LaserBase MF6530
LaserBase MF6540PL
LaserBase MF6550
LaserBase MF6560PL
LaserBase MF6580PL

MF6500-020
(F9-T01-M00-10041-01)

Improving the reliability of contact area between the contact spring unit and the cartridge

P-2 Contact spring unit

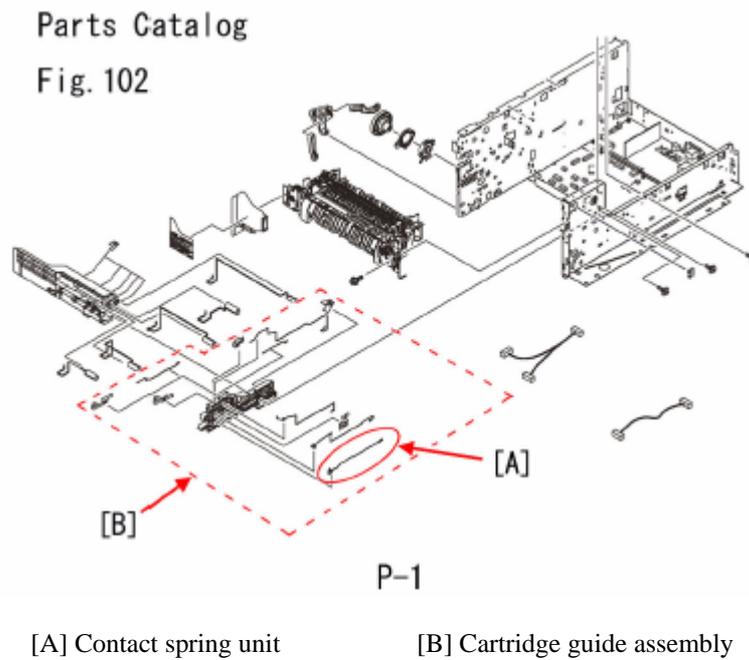
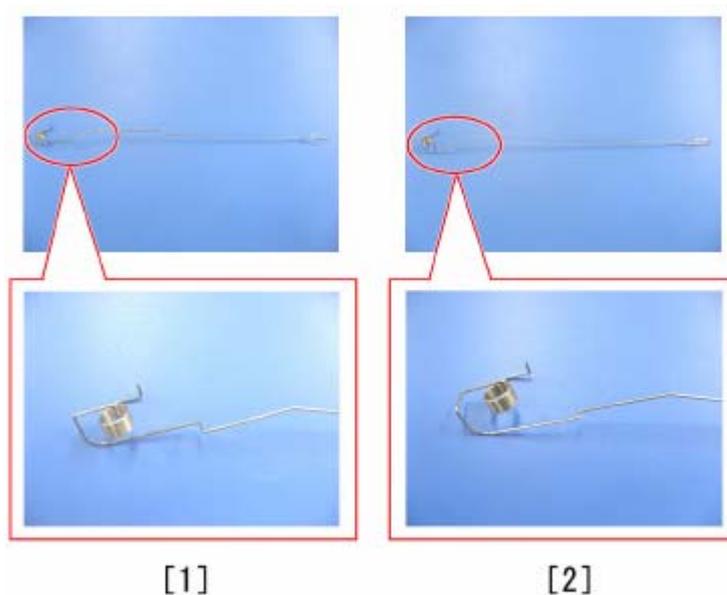
Additionally, the new shape of contact spring unit and adjacent parts are newly set up as the cartridge guide assembly [B].

When replacing the contact spring unit of a machine having a serial number earlier than the ones listed in the “Affected machines” section below, use the old type contact spring unit [1], or perform the replacement with the cartridge guide assembly (FM3-2400).

For a machine having one of the serial numbers listed in the “Affected machines” sections below, use the new type of contact spring unit [2], or perform the replacement with the cartridge guide assembly (FM3-2400).
